<b>DART AEROSPACE LTD</b>	<b>Work Order:</b> 774/9
<b>Description:</b> Crosstube Assembly (205/212/412 High Fwd)	<b>Part Number:</b> D212-664-141
<b>Inspection Dwg:</b> D212-664-141 Rev: D	<b>Page 1 of 1</b>

DRAWING NO. D212-664-141	TITLE XTUBE ASSY (205/212/412 HI FWD)	REV. D	DART AEROSPACE LTD ENGINEERING ORDER		D.E.O. NO. D212-664-141-D-1	SHEET NO. SHEET 1 OF 2	SCALE NTS
DRAWN	CHECKED	UP	MFG. APPR.	RE	APPROVED	MP	DE APPR.
DATE 11.04.07	DATE 11.07.11		DATE 11.04.12		DATE 11/04/12		DATE 11.04.12

DRAWING NO. D212-664-141	TITLE CROSSTUBE ASS'Y (205 HI FWD)	REV. D	<b>DART AEROSPACE LTD ENGINEERING ORDER</b>		D.E.O. NO. D212-664-141-D-2	SHEET NO. SHEET 1 OF 1	SCALE NTS
DRAWN <i>UP</i>	CHECKED <i>A.S.S</i>	MFG. APPR. <i>AS</i>	APPROVED <i>MP</i>	DE APPR. <i>MP</i>			
DATE 11.07.15	DATE 11.07.20	DATE 11.07.21	DATE 11/07/21	DATE 11.07.21

**D212-664-141/-141B  
ASSEMBLY DETAIL**

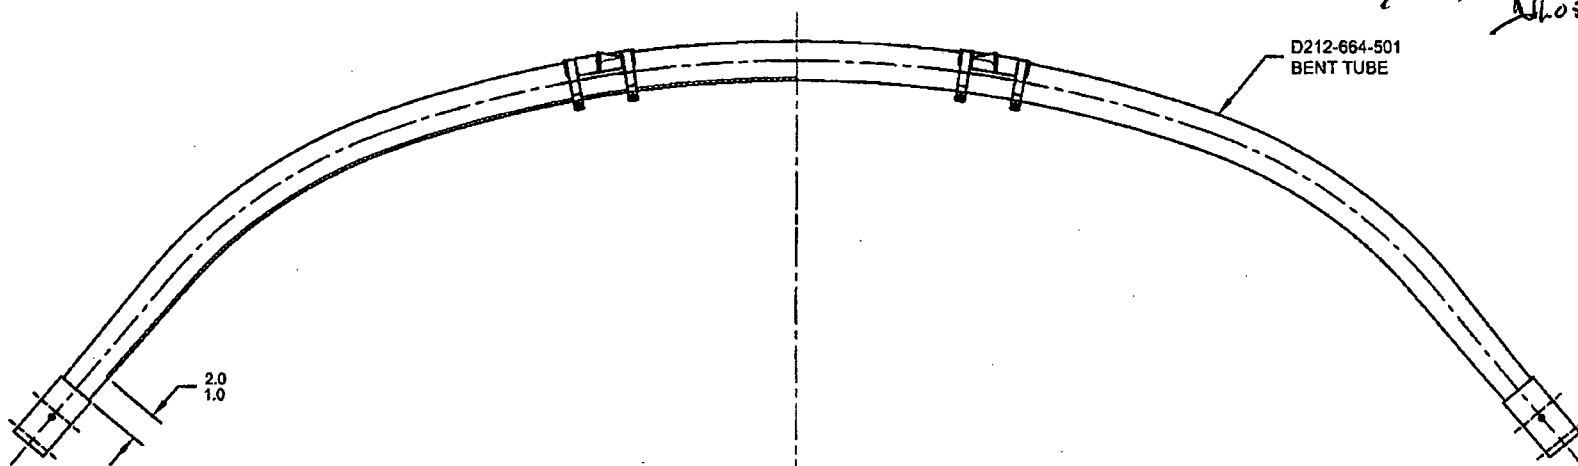
ADD AN INSPECTION WINDOW TO UNDERSIDE OF CROSSTUBE.

NOTES 2 OF SHEET 1 IS AMENDED AS FOLLOWS:

- 2) FINISH: CHEMICAL CONVERSION COAT PER DART QSI 005 4.1  
PRIME INSIDE AND OUTSIDE PER DART QSI 005 4.2  
MASK UNDERSIDE OF CROSSTUBE AS SHOWN (HATCHED AREA) AND  
PAINT OUTSIDE PER DART QSI 005 4.2  
REMOVE MASKING AND APPLY CLEAR COAT

MASK AREA PRIOR TO PAINTING,  
REMOVE MASKING AFTER PAINT  
AND APPLY CLEAR COAT
